Interim Reclamation Inspection

April 2, 2019

Location ID: 426721

Location Name: Hergert /35-D Facility

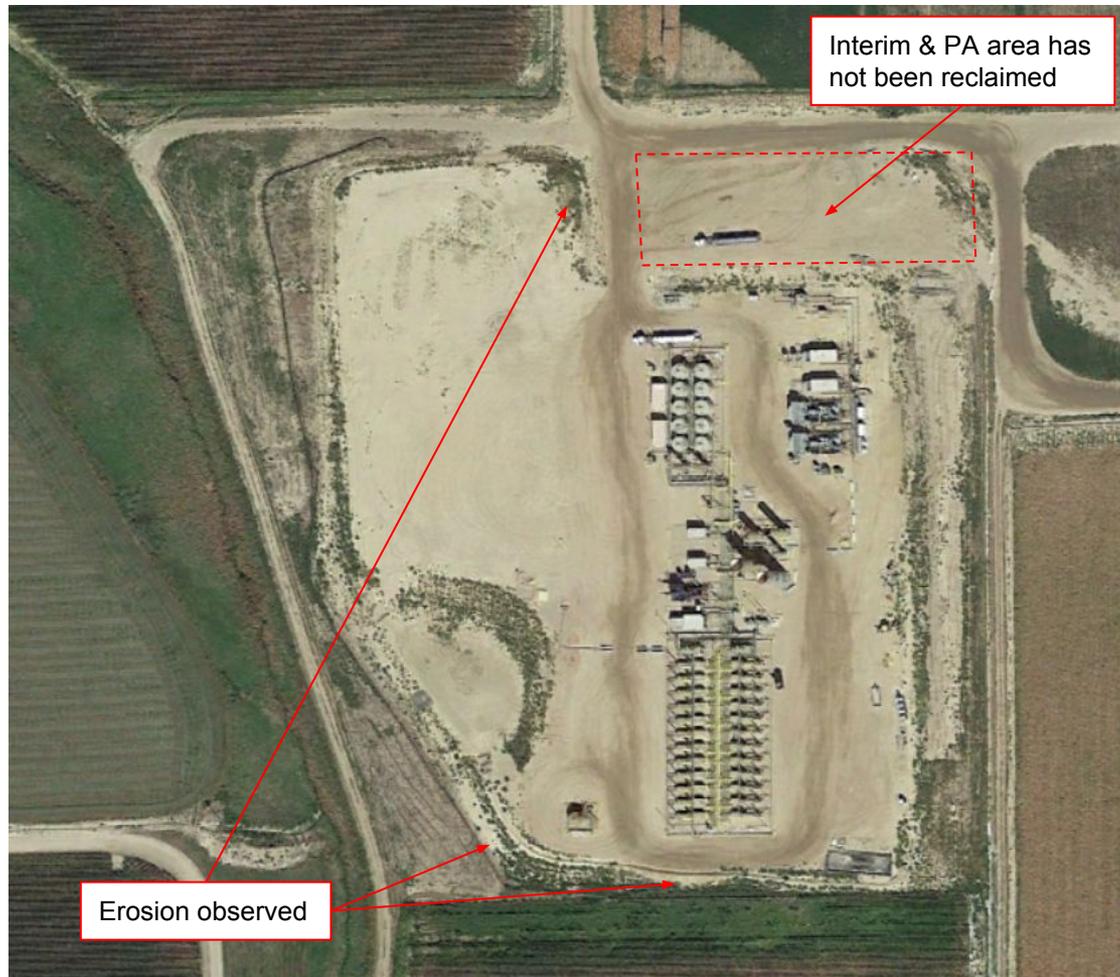
Google Earth aerial imagery taken September 12, 2018 illustrating the Hergert 35-D Facility Location. At the time of this inspection on April 2, 2019, an area located to the north has not been reclaimed and stormwater erosion was observed along the northwestern and southern perimeter of the location.
